Access Compliance Report Public Rights-of-Way (Curb Ramps)

Main Street: HEWES_AVE Cross Street: OAK_RIDGE_DR Location: NE

ADA ID: RPAT211015092746 Ramp Type: Type 4 - Parallel Initial Pass/Fail: Fail Overall Compliance: No Severity Score: 16

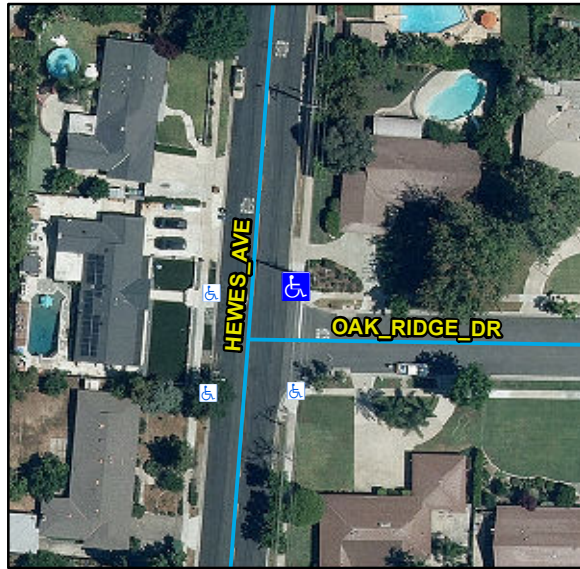
R304.3.2, R304.5.3, R302.3, R402.2, STD 1115

Remove & Replace Curb Ramp With Two New Directional Ramps or Equivalent.
